Safety Alert

Sikorsky S76A+ and S76A++ Helicopters

SERVICE BULLETIN

ARRIEL 1**No. 292 77 0330****Subject: Installation of a sealed Power Turbine (PT) overspeed tachometer box.****Incorporation of modification TU 330.**

ANNEXE 1 / APPENDIX 1

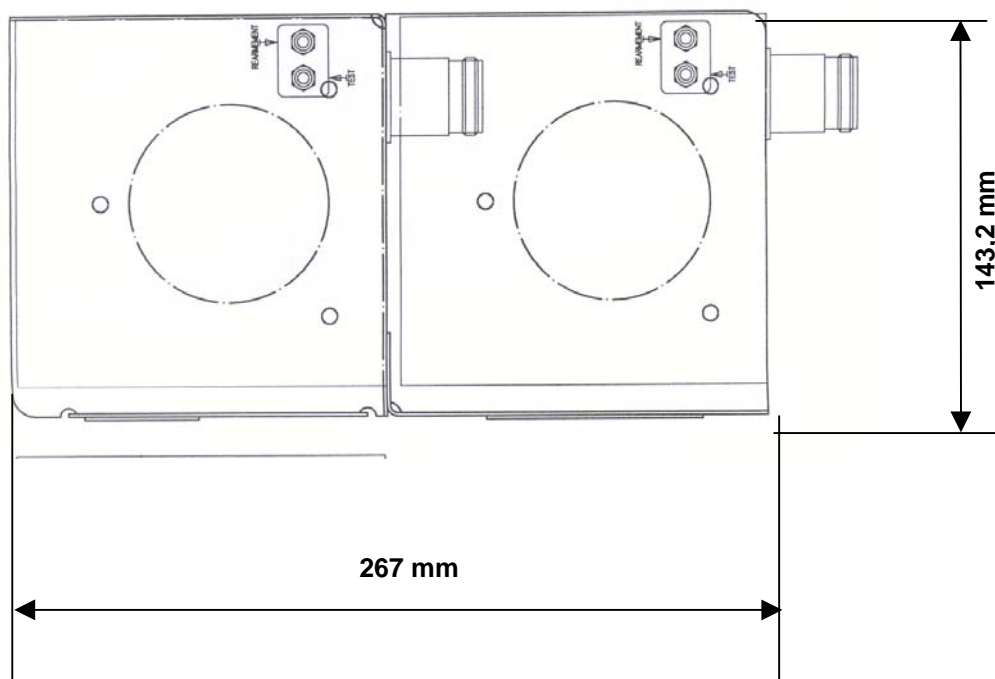
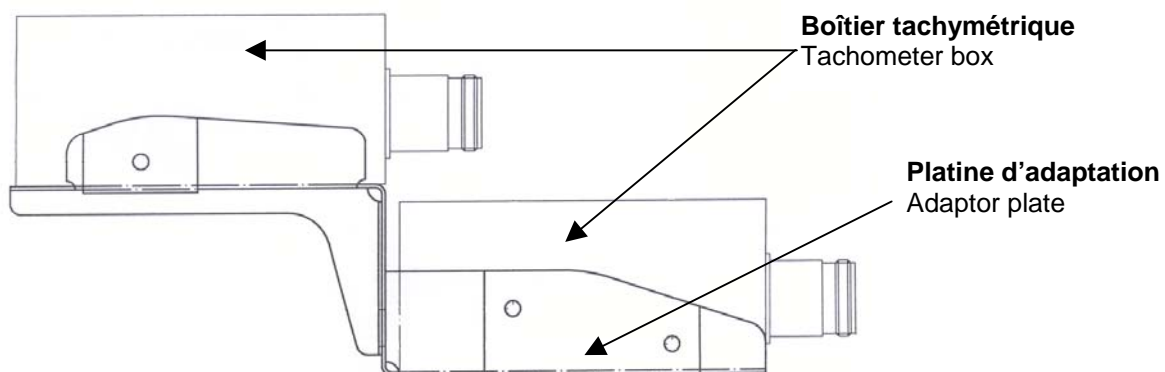
This modification consists of introducing the post TU 330 tachometer box as an option in order to allow the replacement of pre TU 330 boxes that show traces of corrosion or that are used in humidity-saturated atmospheres.

This replacement requires a new adaptor plate that is compatible with all boxes manufactured by TURBOMECA.

(a) Remove pre TU 330 PT overspeed tachometer box: refer to the Helicopter Maintenance Manual.

(b) Replace adaptor plate (supply under Aircraft manufacturer's responsibility): refer to the Helicopter Maintenance Manual.

(c) Install post TU 330 PT overspeed tachometer box: refer to the Helicopter Maintenance Manual.
